ADDENDUM NO. 2:
The following changes and additions shall be made to the plans and proposal. When this addendum conflicts with the specifications, plans, or special provisions, or Addendum # 1, **THIS ADDENDUM SHALL GOVERN.**

Changed to use one Controller		RPG	5/24/05
No.	Revisions	By	Date
CITY OF WICHITA			
TRAFFIC SIGNAL PLAN			
KELLOGG & TYLER ROAD			
SEDGWICK COUNTY			
Professional Engineering Consultants, P.A.			
300 S. TOPEKA • WICHITA, KANSAS 67202 316-262-2691 • FAX 316-262-3003			
Designed by	RPG	Checked by	BER
Drawn by	JGP	Date	Apr 11 2002
		Job No.	97362

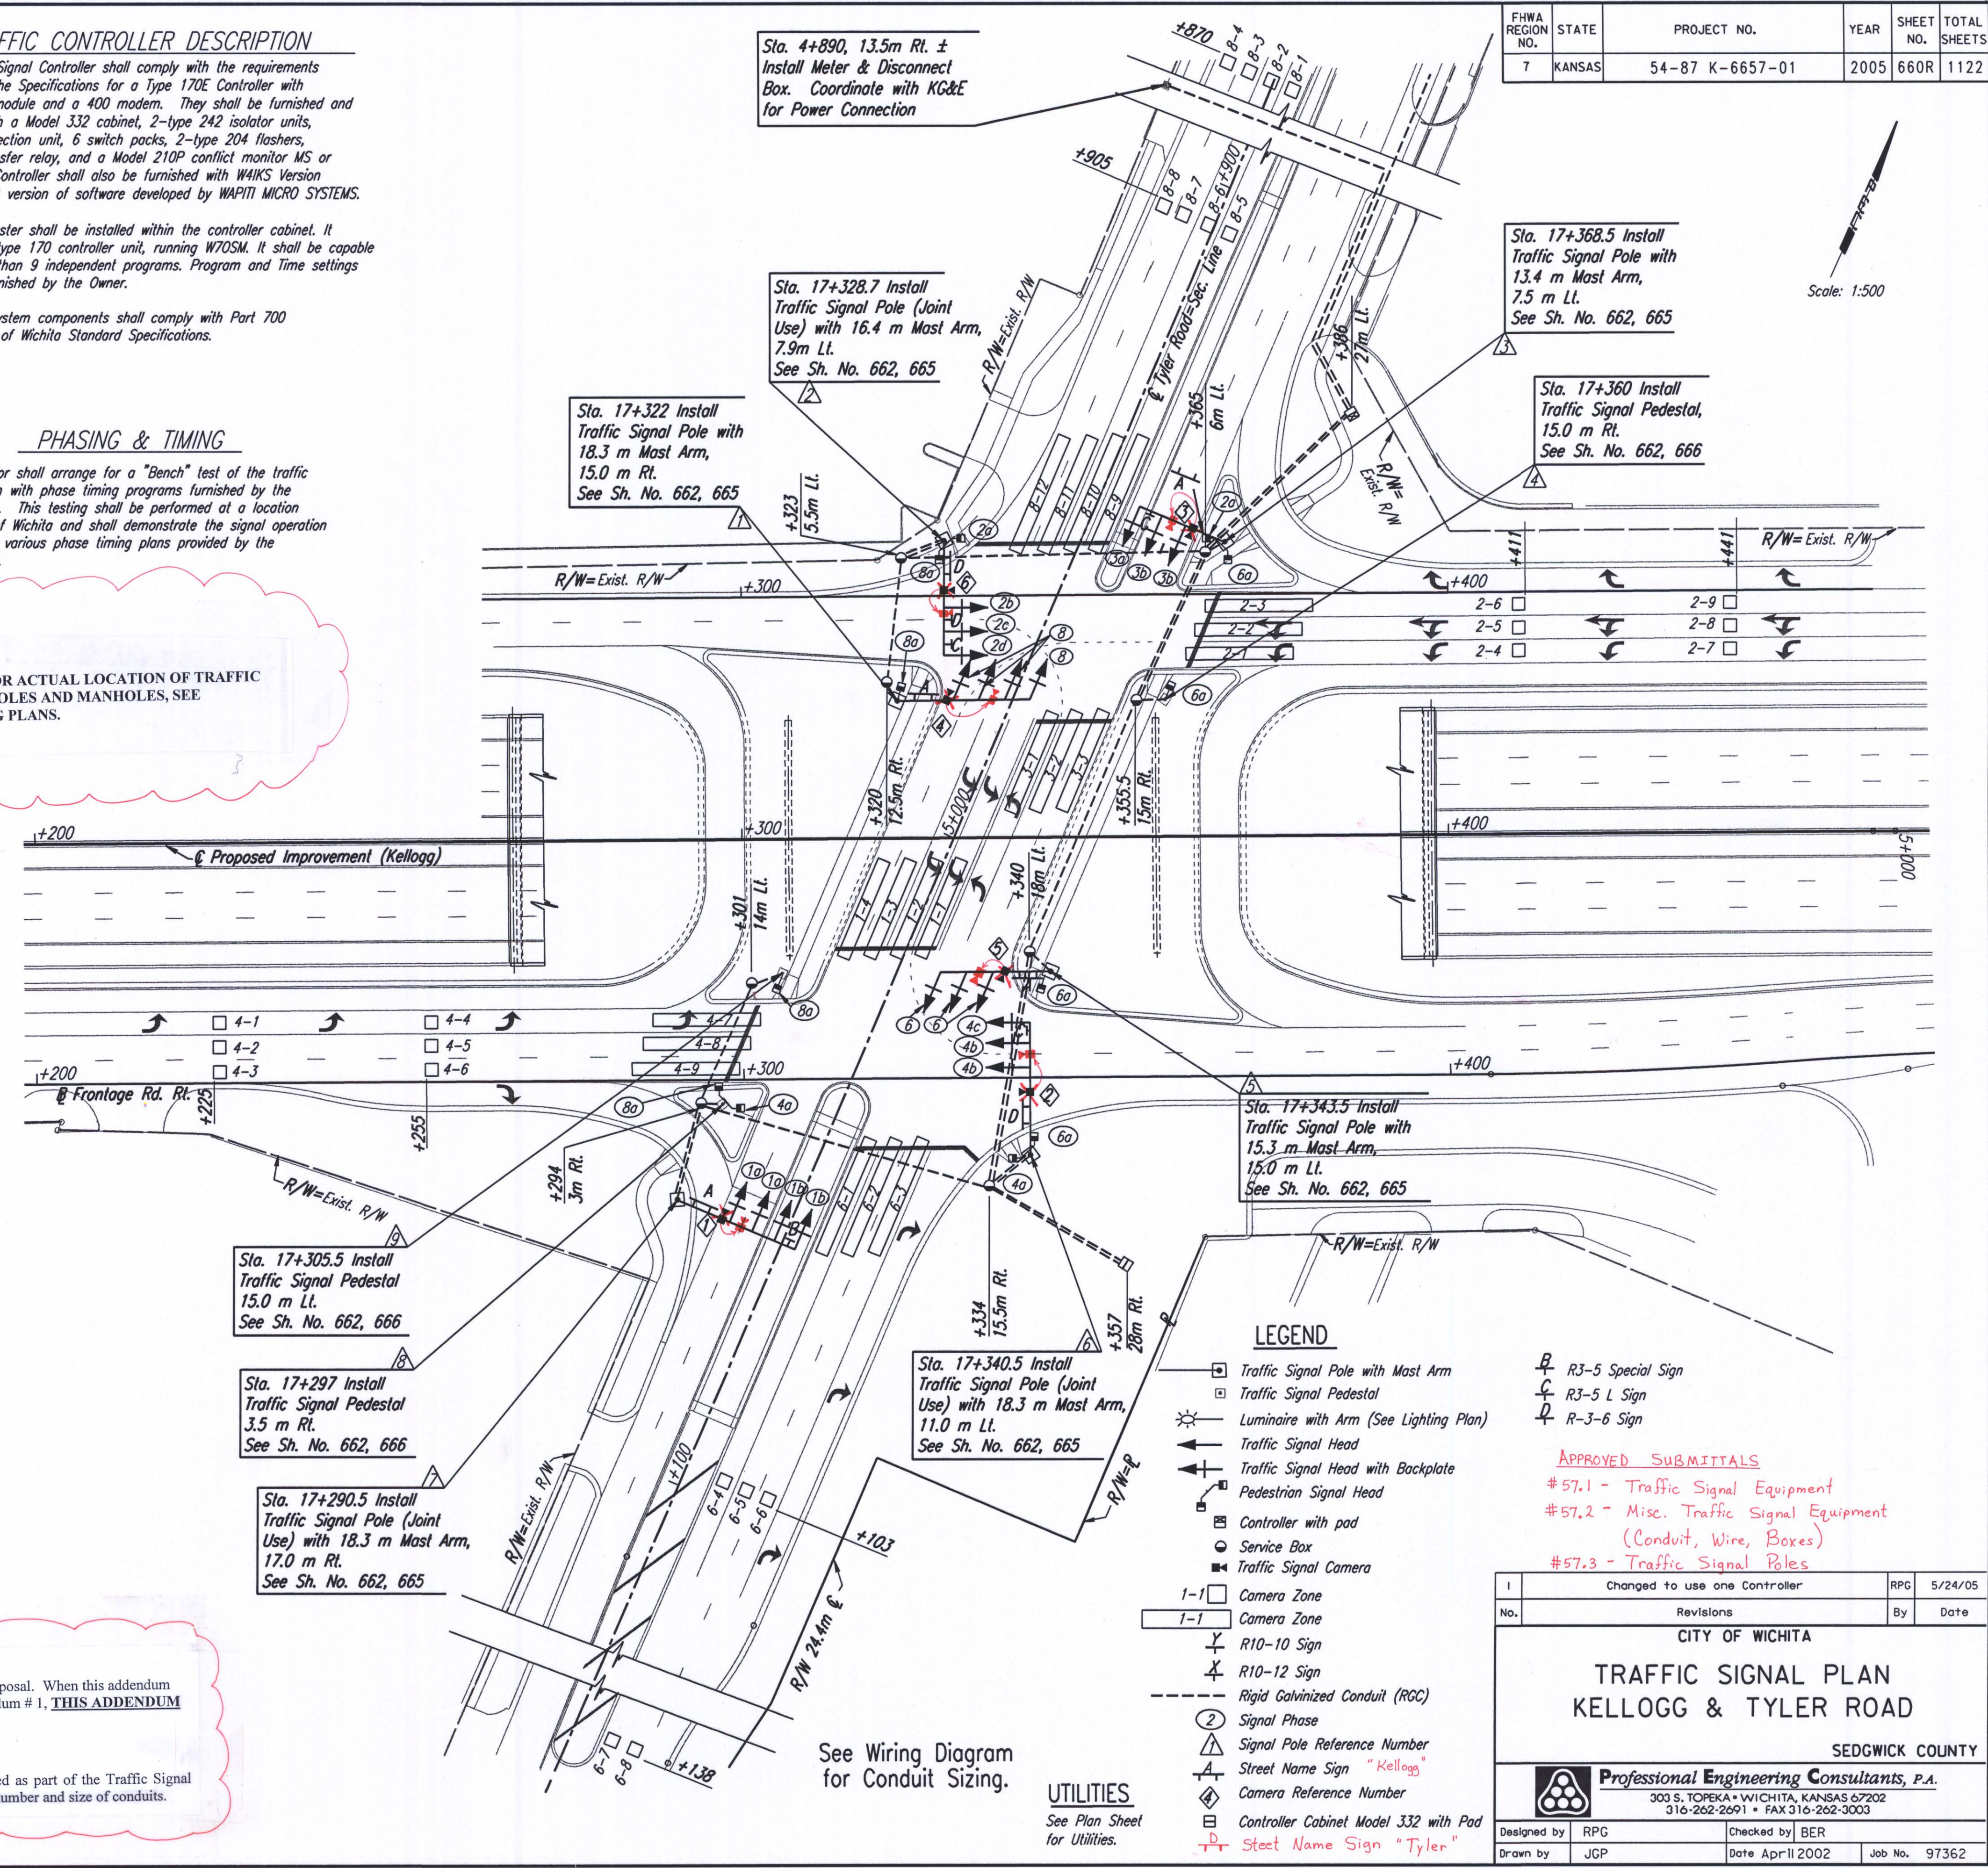
- Sheet 660
- Add Note: Conduits for joint use light poles shall be included as part of the Traffic Signal Installation. Refer to the wiring diagram on Sheet No. 661 for number and size of conduits.
